4000404 CONCRETE STRUCTURES
COMMENTS FROM INTERNAL/INDUSTRY REVIEW

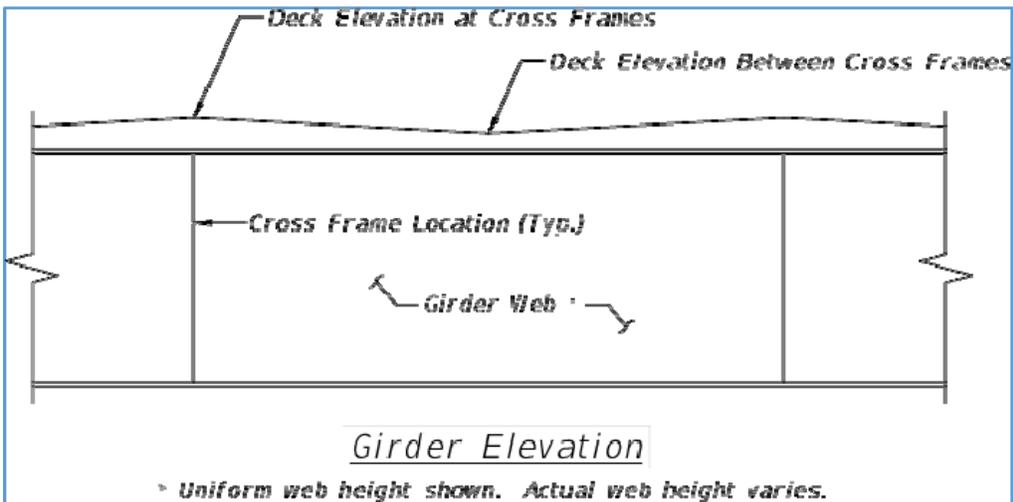
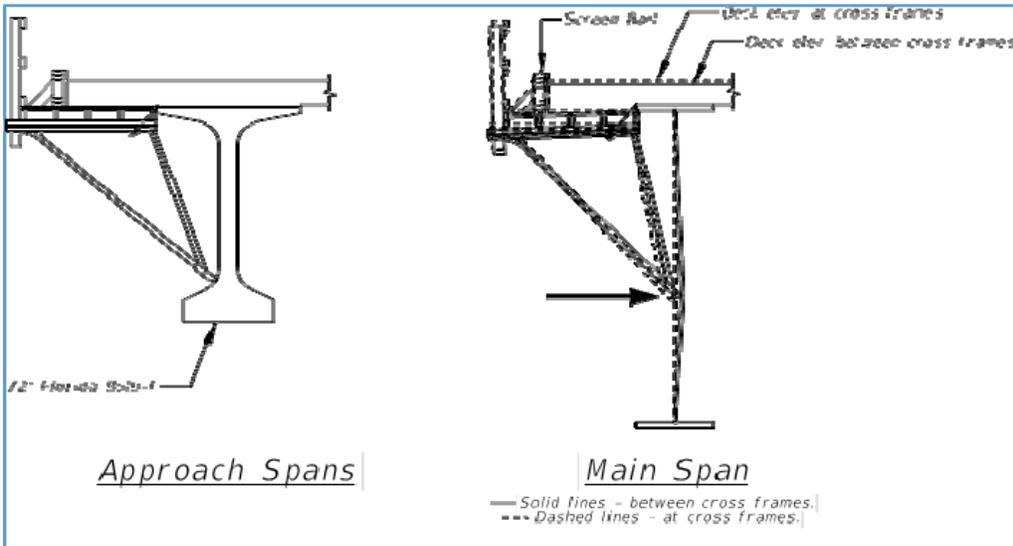
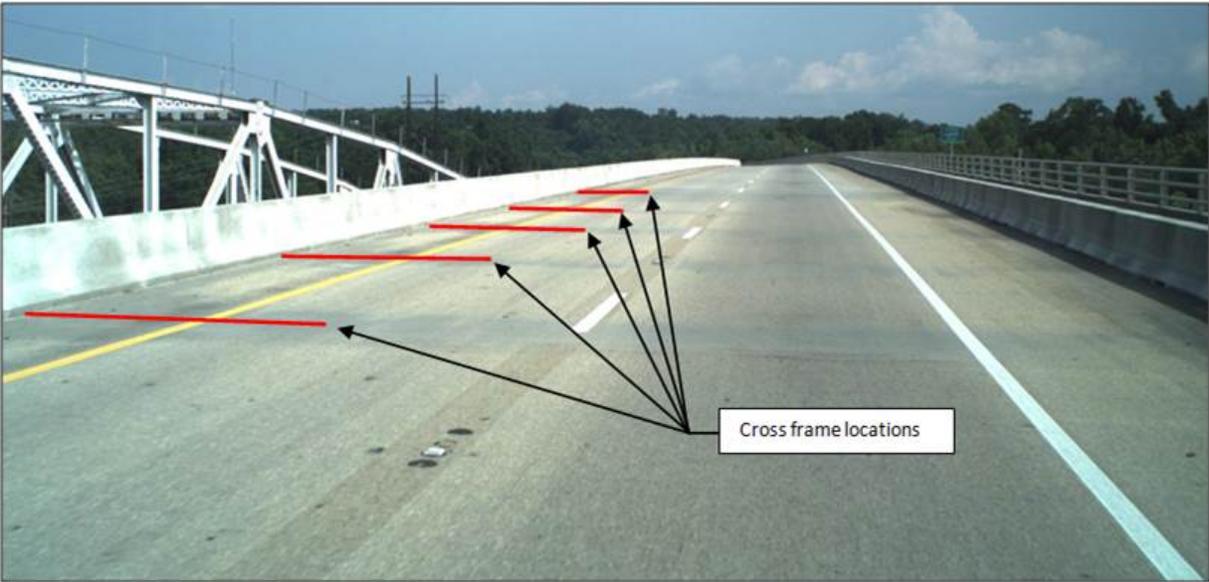
Most long span steel we see is in locations that fall under “public safety” and would require signed & sealed calculations anyway. I see this as a means & methods thing that hasn’t been a problem for years. Why add to the specifications now?

(Robert Robertson response): The issue of beam rotation and the need to control the location of the overhang deck form has been known for many years and improper brace locations have been witnessed many times over the years and is still being done today. This is not a new problem that we are resolving as it a discussion point in a Construction self study course and acknowledged by Steve Plotkin in an NCHRP survey in 2005. We offered the language in an effort to be preventative and minimize efforts by the contractor to meet deck acceptability standards. AASHTO discusses the issue in both the Construction and Design specifications. We initiated the spec revision as part of our effort to evaluate girder stability that also resulted in new requirements for temporary beam bracing. I do not know why this requirement was not already included in the specifications, or at least as a specification requirement for the Specialty Engineer to properly evaluate the specific issue. Generally the Specialty Engineer calculations we have seen are more about global stability and not inclusive of this issue.

Keep in mind that this is language written to the designer and is mostly intended as a strength check, not a constructability check. For conventional design-bid-build projects the designer can't possibly know or accurately predict what bracket size and spacing the contractor will use. Even in a design-build scenario the designer will not likely have the necessary information from the contractor to properly consider the need for temporary bracing during the design. The Contractor's Engineer should be responsible to investigate the need for temporary bracing because the deck overhang falsework size, spacing, and construction loads are only known at the time of construction. See the following from Article 11.8.6.1.2 of the AASHTO LRFD Bridge Construction Specifications:

A sensitivity study performed by our office shows that if bridge deck overhang falsework bears more than 6" above the bottom flange and/or the concrete deck overhang is 4 feet or greater, the deflections of the screed rail between cross frames can well exceed 1/4", with some deflections well exceeding 1/2". These deflections may or may not be correctable with grinding of the deck. Section 400-15.2.5.5 (smoothness evaluation for long bridges) requires that a minimum of 1/4" of the deck be planed off, and allows up to 1/2" of deck planing to meet the smoothness criteria; however, it is not preferred or recommended to eat into the 1/4" of reserve thickness.

This is not a new problem and has been observed in Florida and around the country. This picture is from SR 20 over Apalachicola River. The cross frame locations are clearly visible after deck grinding. The contractor used the same overhang brackets on the steel plate girder main span structure that were used for the 72" Florida Bulb-T approach span beams. The overhang brackets were braced too high on the girder web resulting in web distortion and problems with the deck profile. The deck profile is rough and water ponds along the toe of the concrete railing. See Steve Plotkin's response to a state survey questionnaire for NCHRP Synthesis 345 - Steel Bridge Erection Practices, 2005: *"Bridge with 9-ft deep girders where overhang brackets did not extend to bottom flange of girders. Webs deflected badly and the deck ride was bad. Had to grind deck for ride and bore holes in deck because of ponding. Ride still bad."*
